Planning Commission

Staff Report

Case No:	18ZONE1010
Project Name:	Jeff Wyler Auto
Location:	5244 Dixie Highway
Owner(s):	DWSB Louisville, LLC
Applicant:	DWSB Louisville, LLC
Jurisdiction:	Louisville Metro
Council District:	12- Rick Blackwell
Case Manager:	Julia Williams, RLA, AICP, Planning Supervisor

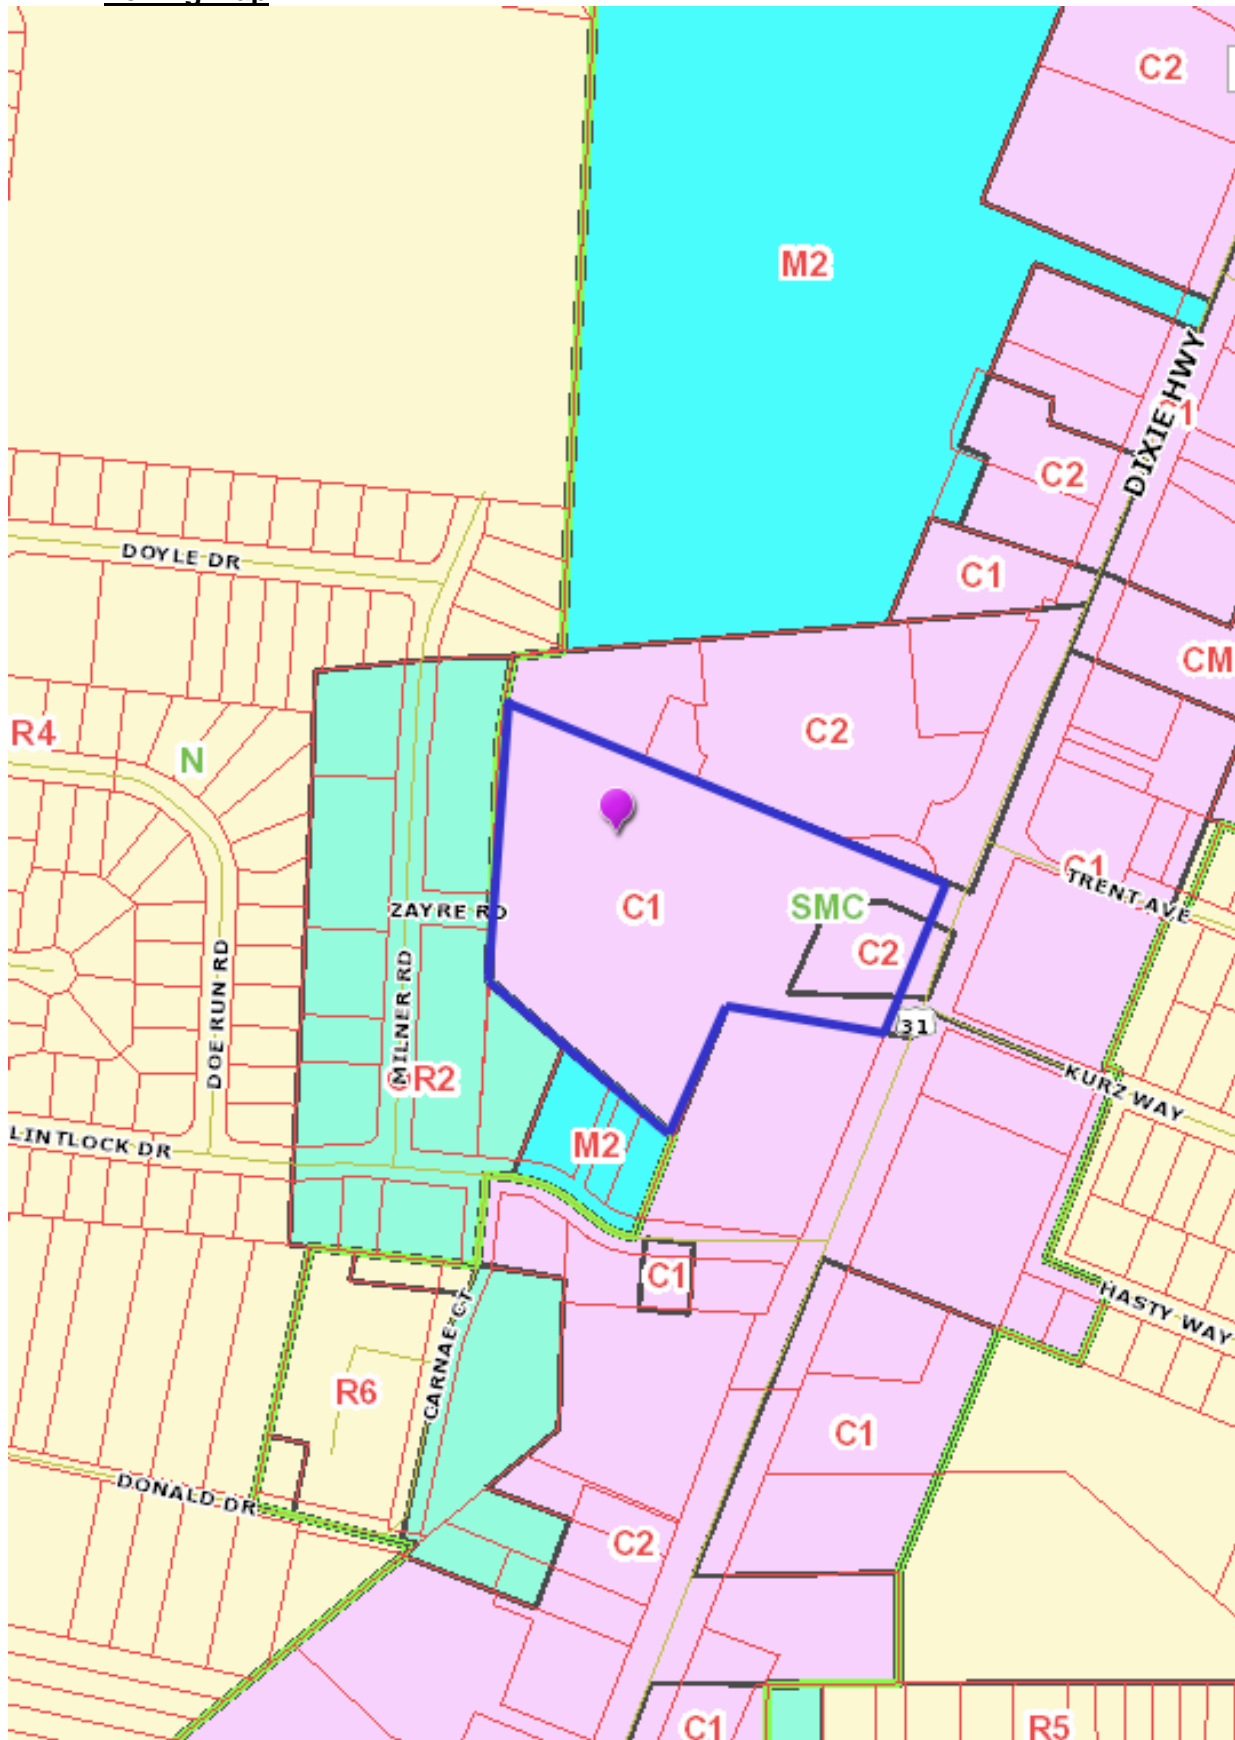
- Transportation Planning is requesting that the plan show the roadway improvements that are being made along this portion of Dixie Highway as part of the "Dixie Do Over".
- Transportation Planning is also asking that the following note be added to the plan: "Right-of-way dedication shall be required, 65' from centerline of pavement within 30 days of Metro Council approval for the re-zoning. Right-of way may be dedicated by a Deed of conveyance or minor plat."
